Attachment 9 – Assessment of compliance with Shell Cove Precinct D Urban Design Guidelines

Shell Cove Precinct D Urban Design Guidelines

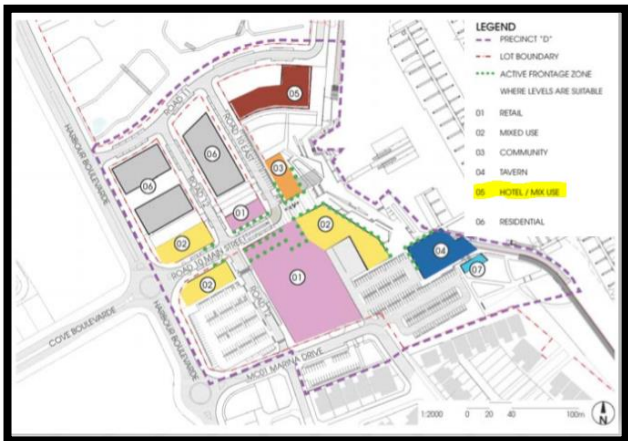
serve areas such as bin store, basement access and loading bay. Figure 9.5 at the end of this attachment shows the blank wall referred to. This area is suitably designed and compliant with this design guideline.
	Design Guideline 6 Lift tower, stair towers, air conditioning plants etc. are to be integrated into the design of the buildings.	Suitably complies as discussed in section 4.iii of the assessment report.
